Product Change Description

[ZTE A2017U]

[Project Number:16ZTE027]

Antenna changes: GPS/WiFi/Bluetooth 3in1 antenna is now updated.

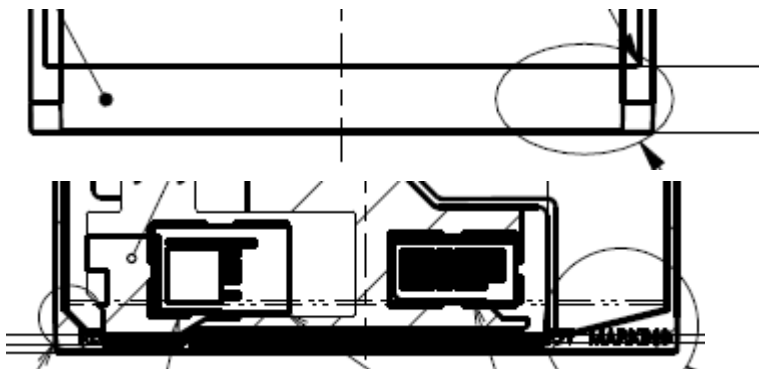
Aiming at improving GPS performance, we updated this antenna and this result to 1dB efficiency better than previous one. Meanwhile, WiFi/Bluetooth efficiency was slightly down.
